**UNITED STATES ENVIRONMENTAL
PROTECTION AGENCY
REGION IX
75 Hawthorne Street
San Francisco, CA 94105**

**STATE OF HAWAII
DEPARTMENT OF HEALTH
P. O. BOX 3378
HONOLULU, HI 96801-3378**

Re: Comments on Environmental Work and Development of the Contaminant Fate and Transport Model for the Red Hill Administrative Order on Consent (“AOC”) Statement of Work (“SOW”)

Attachment 2: Groundwater Elevations with Countors

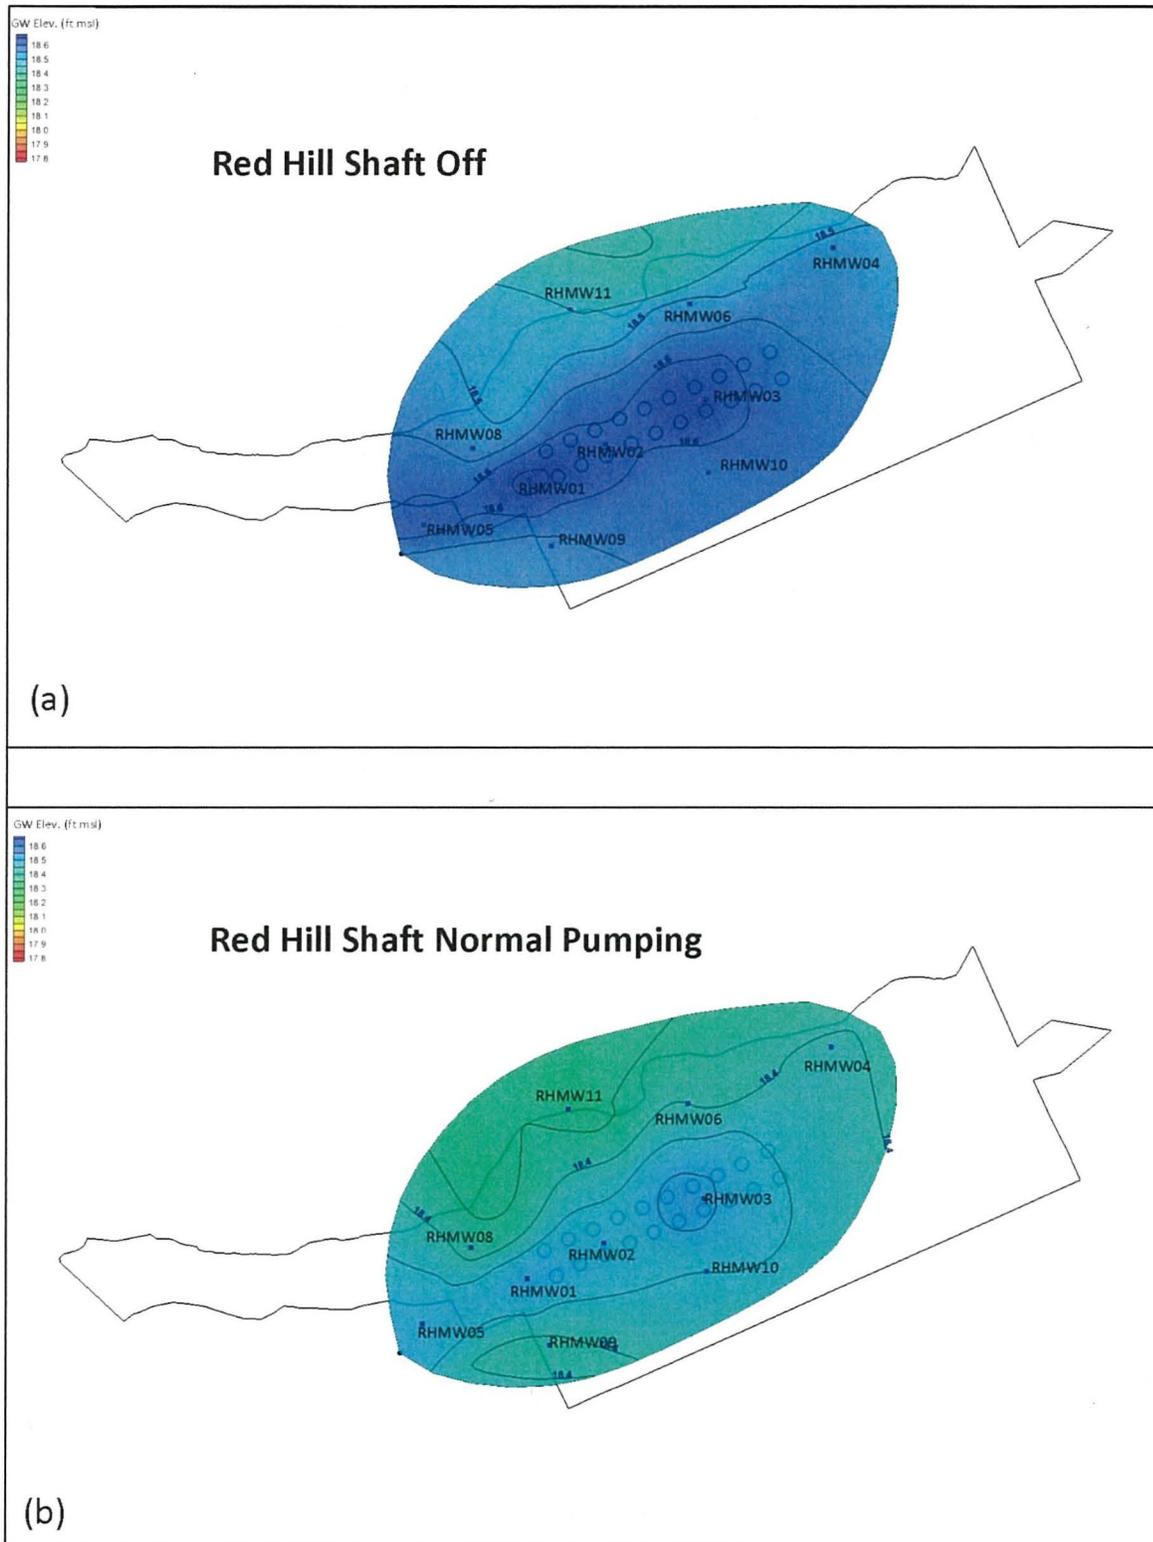
6. Potential Contaminant Transport Pathways Remain Uncharacterized: Current Navy presentations discount the possibility of groundwater flow from the Red Hill Ridge to the northwest. The stated rationale is that groundwater flows from areas of highest recharge to coastal areas or submarine discharge. However, it would be more technically correct to state that groundwater flows from areas of high hydraulic potential to areas of low hydraulic potential. Mink (1980)⁸ recognized that the Red Hill side of Halawa Valley has a higher hydraulic potential than the Halawa side of Halawa Valley. Contours of measured groundwater elevations prepared by the Navy⁹ and shown on the attached figures support Mink's hypothesis because they show very little gradient going down the axis of the Red Hill Ridge and a well-defined gradient to the northwest of the underground tank farms. Under certain conditions, particularly when Red Hill Shaft is not pumping, flow from under the upper tank farm to the northwest may occur given what is currently known about saprolite extent and groundwater use. Given the importance of this issue to the DOH Source Water Protection Program, DOH intends to provide additional technical information on this subject in a separate letter.
